SOUTH JORDAN CITY PLANNING COMMISSION REPORT

Issue: IHC HOMECARE OXYGEN “WAREHOUSE BUILDING B” SITE PLAN

File No: PLSPR202400130

SITE PLAN REVIEW RESPONSE #01 OCTOBER 10, 2024

SHEET NUMBER
AS101

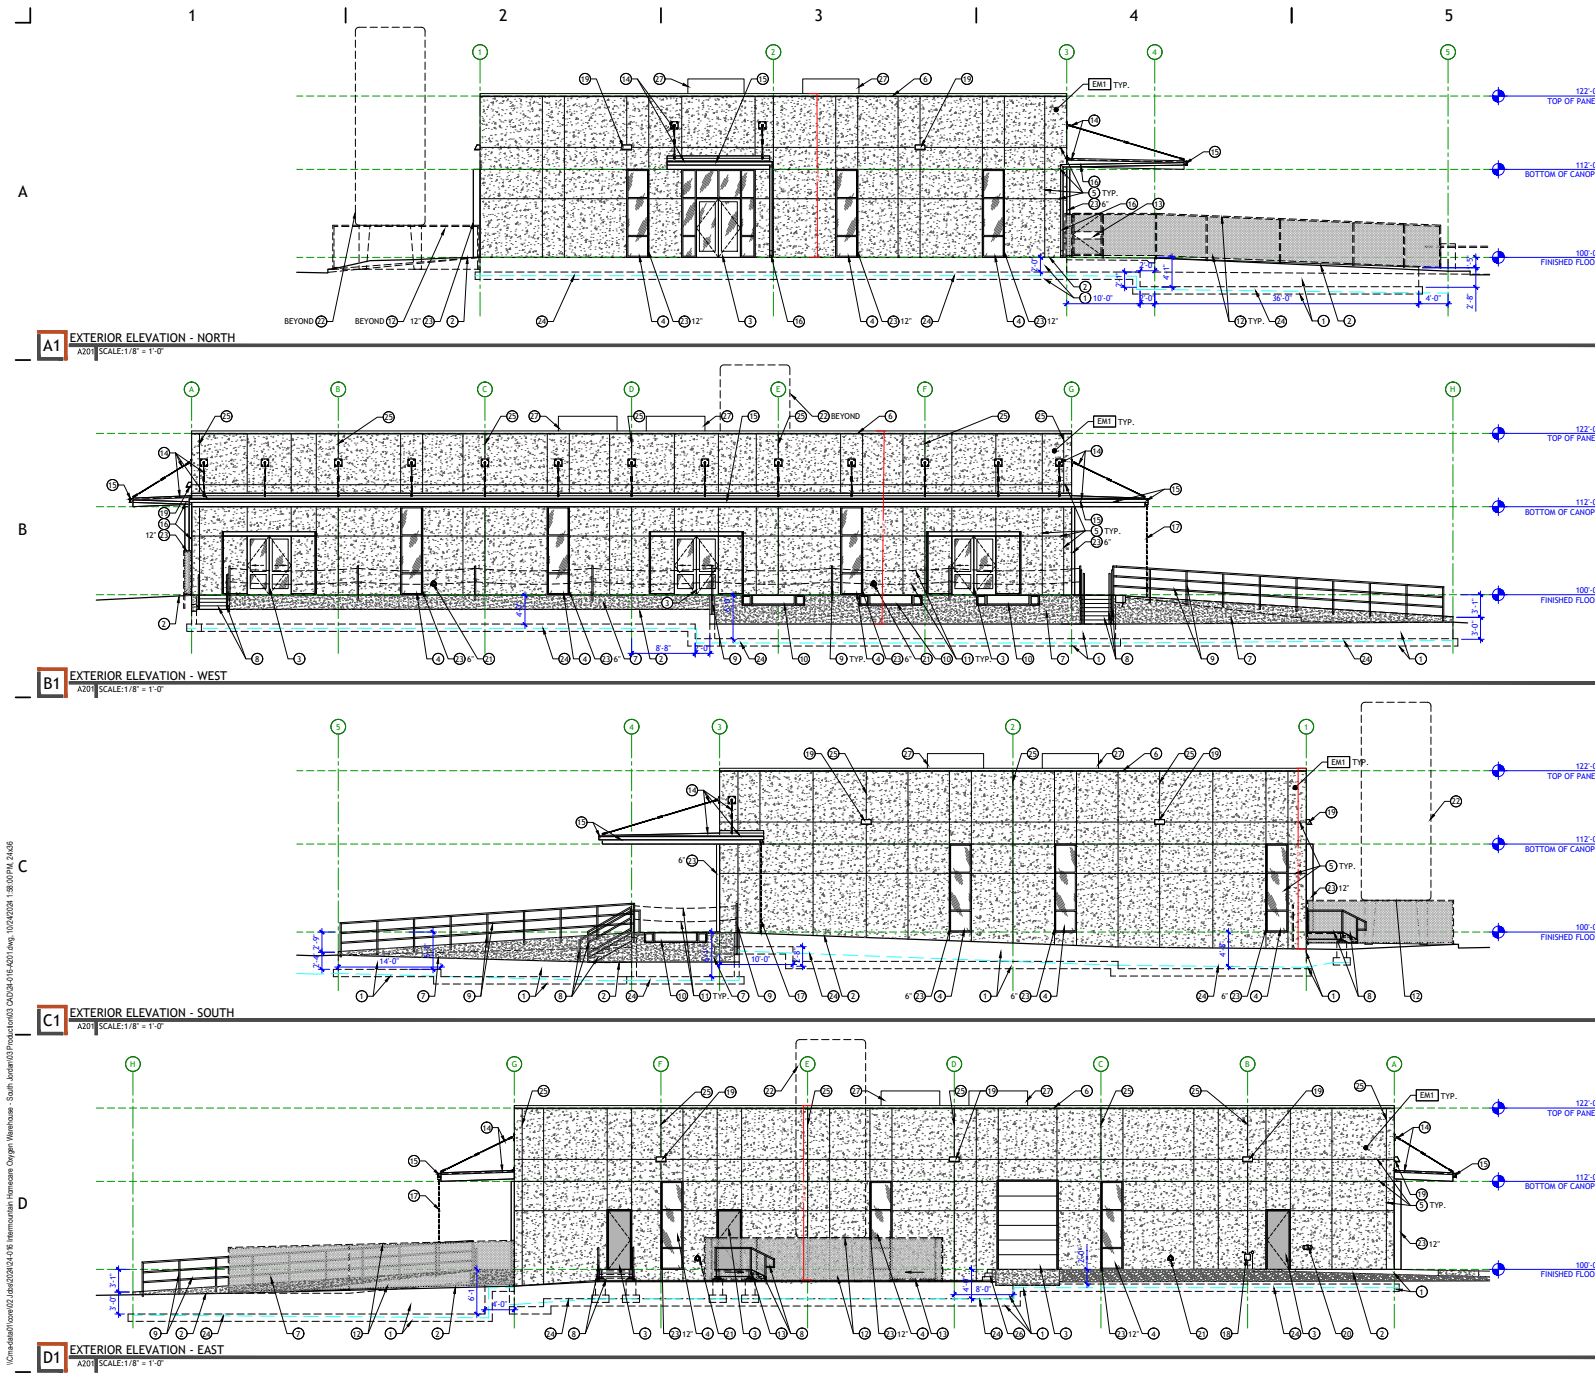
3. Provide a Circulation and Access Plan uploaded to the application using "Additional Documents". The purpose of a circulation plan is to identify a proposed project's potential traffic conflicts generated by proposed access points and vehicular, pedestrian, and bicycle routes. The circulation plan shall show adjacent roads, access points, primary travel routes, drop off and pick up areas, stacking and queuing areas, connections with adjacent properties, and pedestrian and bicycle routes. Demonstrate how the new warehouse addition will incorporate into the existing circulation and access of the site, and will not create any additional impacts to traffic or access. This is required because the project includes a vehicle/loading bay along the west elevation. This document will help the Planning Commission better understand the project, and what is being proposed. The Commission will also keep in mind the proximity to the residential homes to the west, and how all of this could impact them.

8. The use for this project is considered warehousing, distribution, and storage. This requires 1 parking stall per 800 sf² of floor area or 1 parking stall per employee at maximum shift change. According to the dimensions (120' x 132'), the warehouse is 15,840 sf² which requires 20 parking stalls. This Site Plan only shows 17. The other 3 parking stalls required cannot be the stalls dedicated/used/ and numbered for IHC's fleet of vans and trucks on-site.

increase site traffic. The function and employees that currently operate this part of the building's function are currently housed within the existing building. Those functions will just be relocated to this building. See revised AS101 where the circulation and access information has been added.

Response: As coordinated with the city planner, the size as described above is not accurate. See the revised AS101 that includes a parking tabulation breakdown of the net stalls required for this project. Due to other city review comments, the Owner has opted to remove the Add Alternate and build out the remainder of the

Response: As discussed, due to city concerns, the Owner has agreed to plan on building out the rest of the parking lot as part of this project. See the revised Civil, Landscape plans, AS101, and AS101A.

D1 SITE CALCULATION PLAN

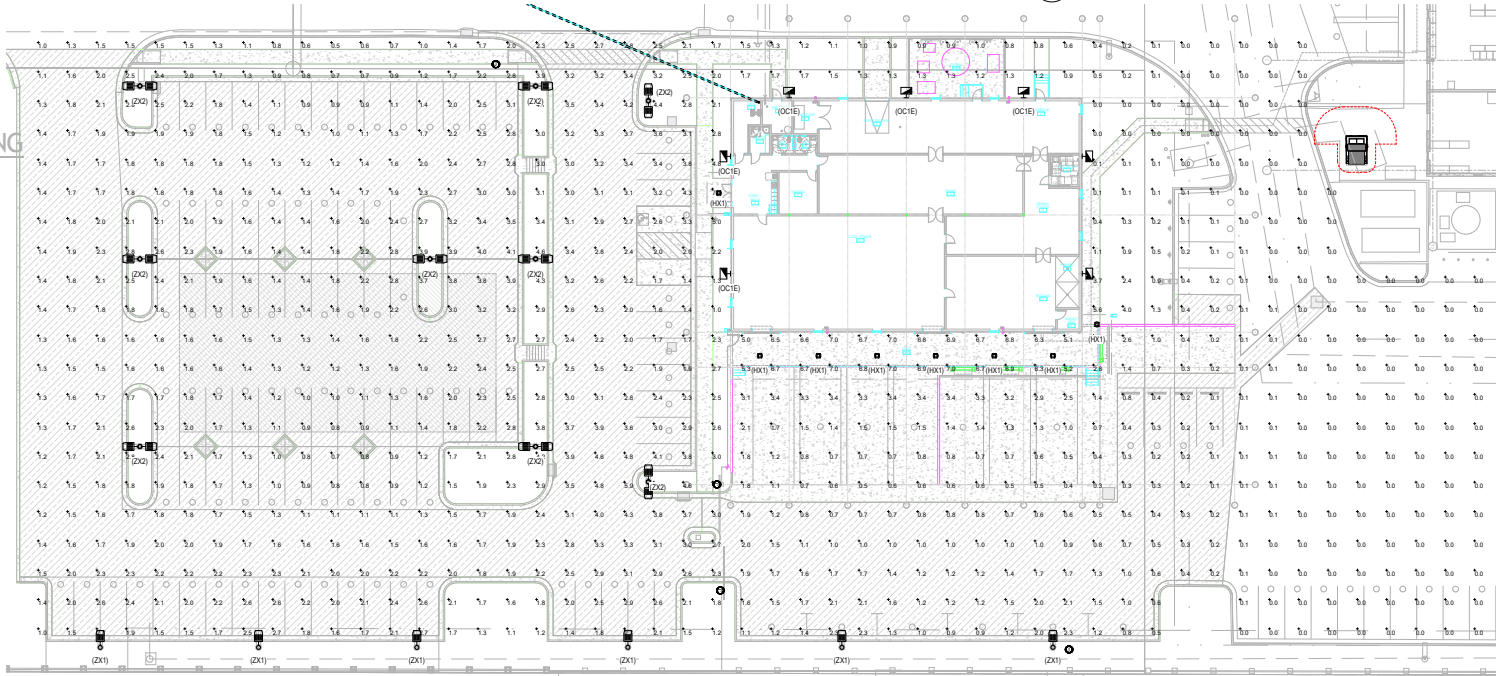
12. These specs are inconsistent with the additional specs provided on sheet EL602. This sheet says that ZX1 AND ZX2 are overall 15' and 20' tall respectfully, however, sheet EL602 lists that both ZX1 and ZX2 are both 27'. Which is the correct height? The lighting specs also needs to indicate the shielding being used.

Response: ES201A was correct and EL602A was incorrect. The required shielding notes have also been added to the fixture schedule. The light poles will be 20 p in the parking lot area and 15' on the outer perimeter near the property line. See the revised ES201A and EL602.
